LAKE BARNEGAT DAM NJ 00058

PHASE 1 INSPECTION REPORT NATIONAL DAM SAFETY PROGRAM

REPORT DOCUMENTATION PAGE		READ INSTRUCTIONS BEFORE COMPLETING FORM
1. REPORT NUMBER • NJ00058	2. GOVT ACCESSION NO.	3. RECIPIENT'S CATALOG NUMBER
4. TITLE (and Subtitle) Phase I Inspection Report National Dam Safety Program Lake Barnegat Dam Ocean County, N.J.		5. TYPE OF REPORT & PERIOD COVERED (9) FINAL rept.

NAPEN-D

SPILLWAY DETAILS
FIGURE 3

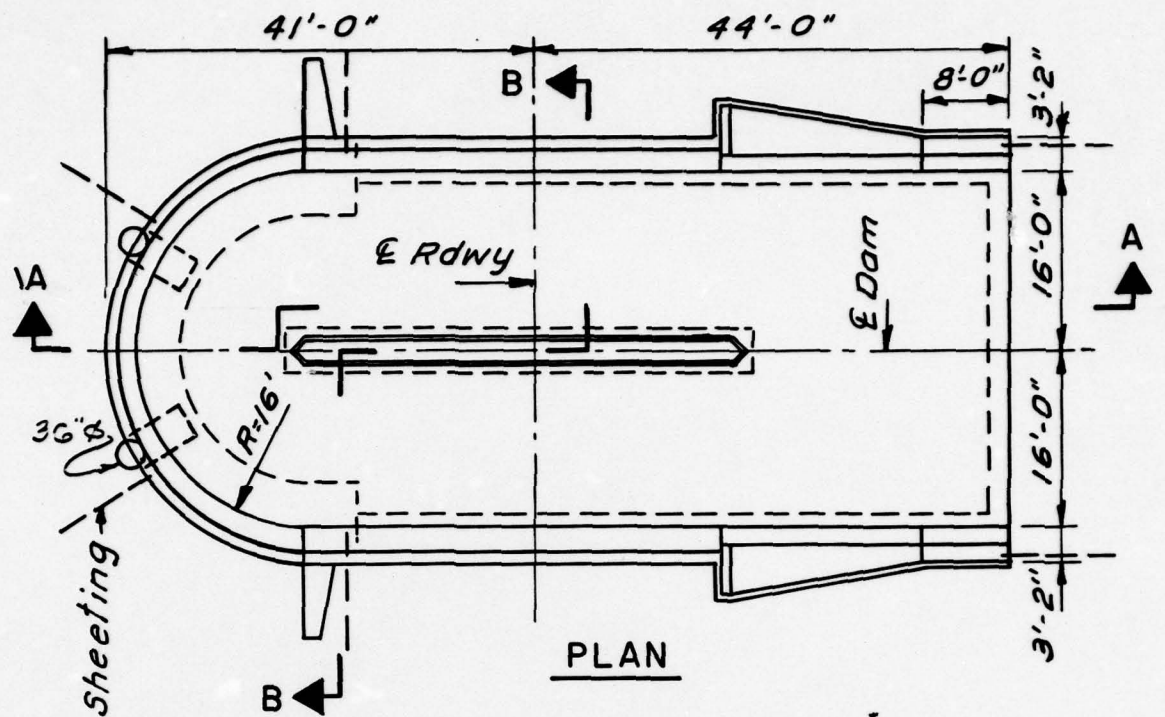
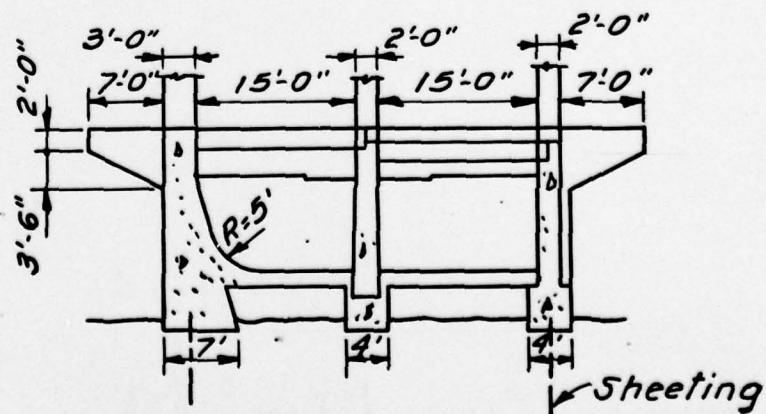
(1) The deteriorated areas of the exposed concrete surfaces should be patched, especially on the top of the curved crest of the spillway. Also the tops of all joints should be cleaned out and caulked.

View of Spillway Outlet

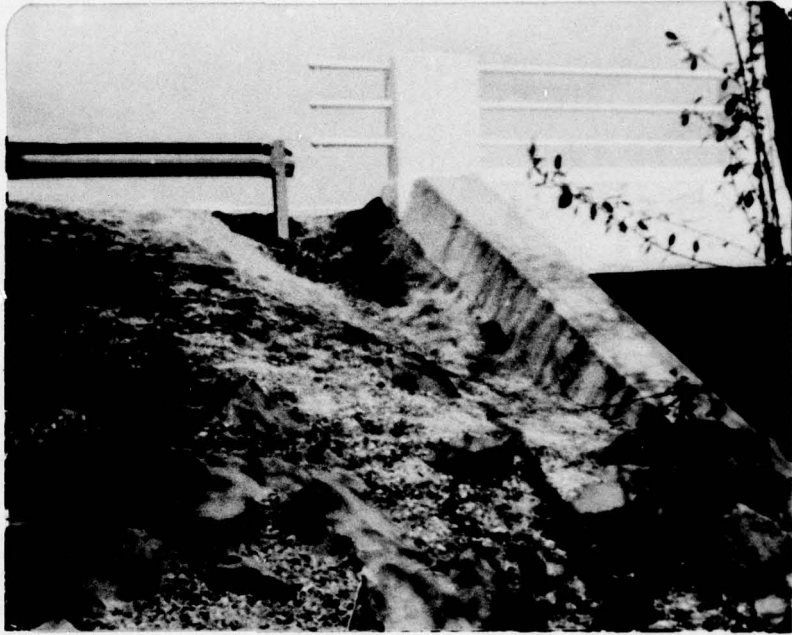
The bridge superstructure has 2 fifteen foot clear spans and is in satisfactory condition but the center pier and downstream wingwalls of the substructure have several pronounced cracks and spalled areas. The perimeter of the footings are protected by 3 inch T.&G. timber sheeting (12 feet long) but the walls are founded on spread footings and are not pile-supported; a questionable design configuration in the opinion of the inspection team. However, the structure has stood for almost 45 years with little evidence of serious differential settlement. According to construction records, the muck cedar swamp bottom soils were excavated down to elevation zero where a dense clean sand formed the load-bearing stratum.

View of Erosion - Right Wingwall May, 1979

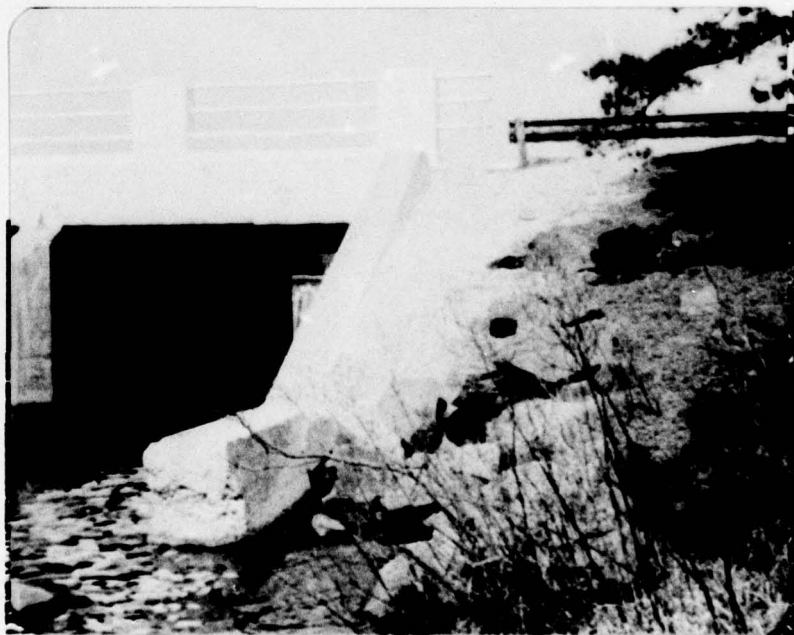
There is considerable localized erosion at each corner of the bridge but stone slope protection has been placed behind the downstream wings.

- Regrade all slopes of embankment and reseed.
- Replace the scoured cavities along the upstream face with stone riprap or other heavy shore protection material.
- Install roadway curbs and drains on each side of the spillway bridge to channelize the surface run-off away from the structure.
